MEMORANDUM

From:	Catherine Brimble Senior Landscape Officer		
Service	WBC Landscape and Trees	App No:	251984
Address:	Land south of Bridge Farm, Reading Road, Arborfield, Berkshire, RG2 9HT.		
Proposal:	Application for approval of Reserved Matters pursuant to Outline Planning Consent 223083 (as varied by 243190) for the erection of up to 11 no. commercial units to provide 6,986sqm GIA commercial / employment development predominantly within Class B8 and/or Class E (g) uses with supporting facilities within Class E uses comprising ancillary offices, trade counters and food/drink facilities with highway works and strategic landscaping. Details of appearance and landscaping to be considered.		
Type of Development:	Major Heavy industry/storage/warehouse		
Site Visit Made:	Yes/No

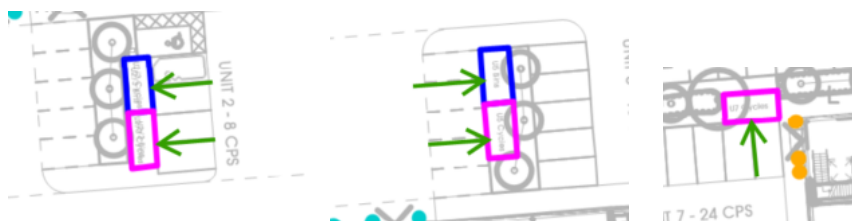
I have noted on the plan showing the cycle and bin store details that in some locations access to these will be through the adjacent parking. It is not clear how this will work if cars are parked in these spaces. Extracts are given below with green arrows I have added to show what I assume to be the access in these locations. I'm concerned that this lack of access could impact on the proposed landscape behind these structures which ultimately will need to be removed to allow access. The routes into the bin stores and cycle sheds will need to be clearly marked to ensure the small amount of landscape planting within the car park areas will be maintained.
